Technical Bulletin

Important information regarding the introduction of KFG housings with 100-120 slotted front mounting holes.

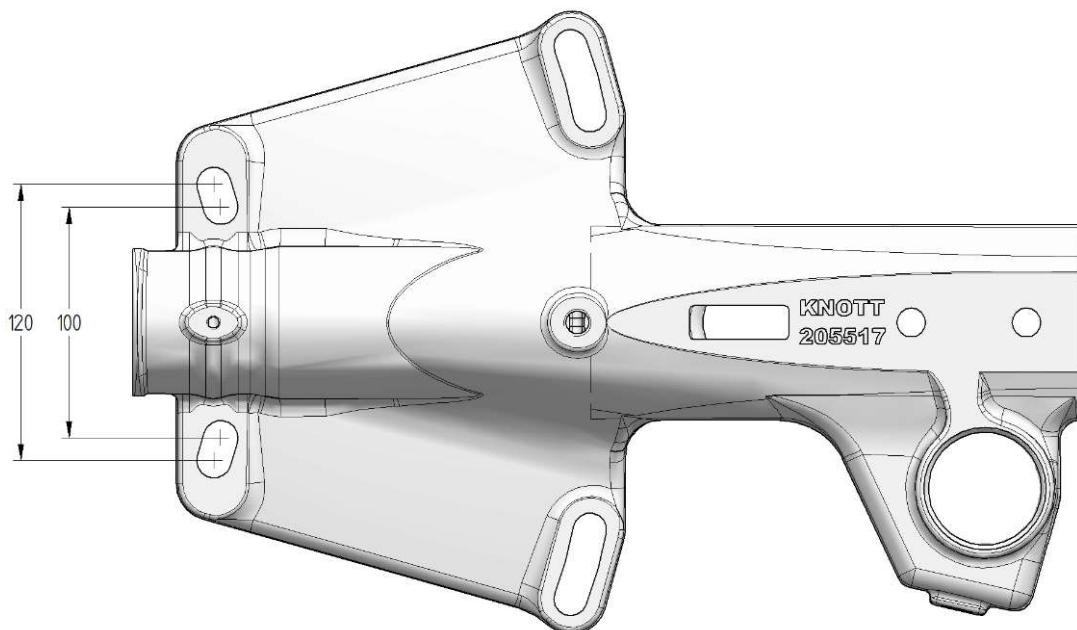
From January 2023, Knott-Avonride will no longer supply the KFG13, 20, 27 and 30 range of couplings with either 100mm or 120mm front mounting holes, instead the housings used will have slotted front holes (see image below). The slots allow for universal mounting with one assembly and the end customer no longer needs to be asked to measure the front hole centres, eliminating the possibility of identifying the incorrect overrun coupling hole centres. Purchasing of product will become more straightforward as the number of possible variants is halved. It also has the benefit of reducing inventory variation and stockholding for Knott, Customers and Suppliers.

The KFG35 housing will remain unchanged and retain a 120mm hole centre.
